London Ashford Airport (Lydd) Call-In Inquiry

**Supplementary Statement of Common Ground
Ditch Mitigation Strategy**

between London Ashford Airport Limited and Natural England

April 2011

Figure 2. Ditch System Plan (Drawing Number WSP 1559-GA-02-C)

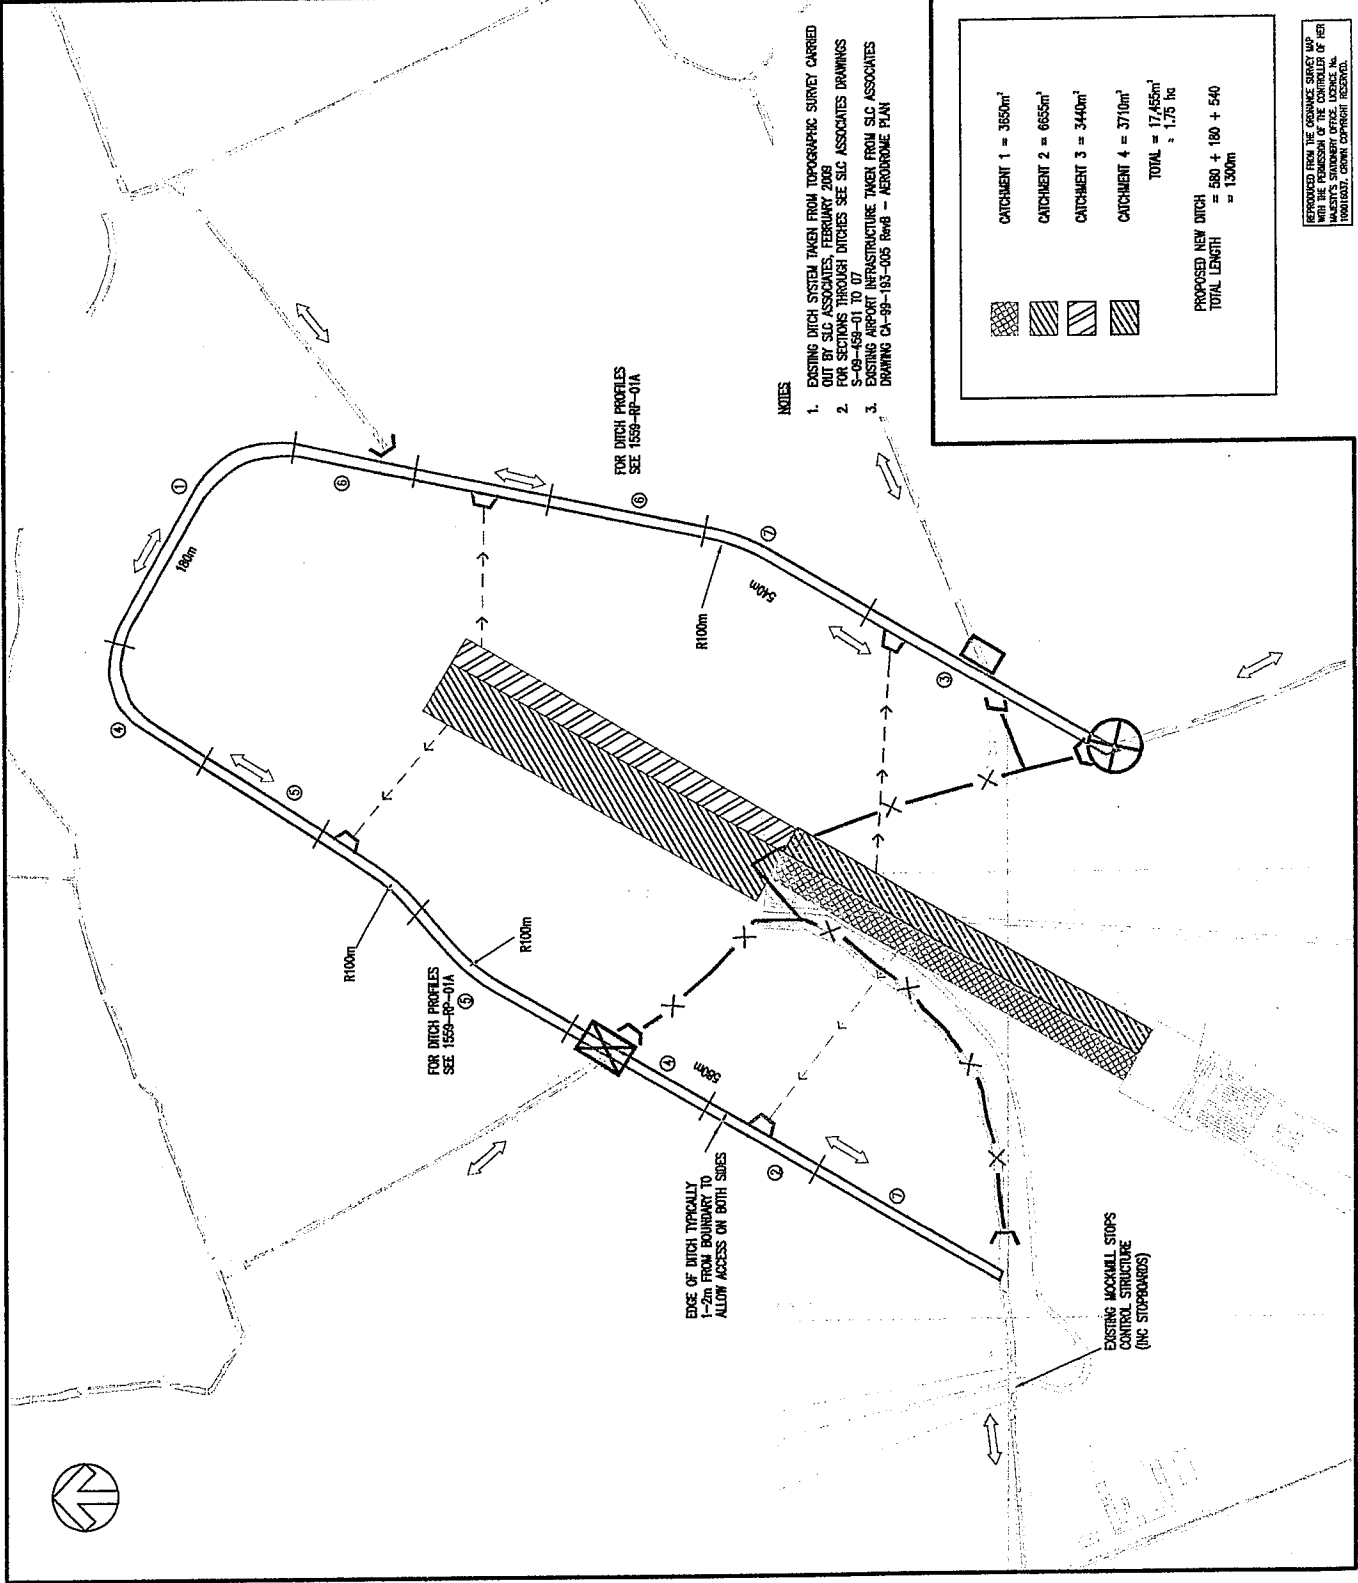
- 3.1.1 The section profiles of the ditch have been designed to provide greater variety and diversity than previously. The 1300m ditch design has been divided into segments of roughly 100m, and a profile assigned to each segment. The incorporation of shelves into the bank profile will allow shallow margins to develop and will provide runs to species such as water vole and common lizard. Southerly facing sections are designed to produce particularly shallow margins. The positioning of most shelves on the Airport side is mindful of operational management requirements of the RMAIDB. The plan and section drawing of this revised design are contained in Figures 1 and 2 of Appendix 1 to this SoCG.

- 3.1.3 Figure 2 of Appendix 1 shows reduced control structures and improved connectivity (Ditch 7 will be connected, whilst Ditch 2 (currently blind-ended), will remain so, and not be connected; for ditch number references see NE/2/A, Figure 1).
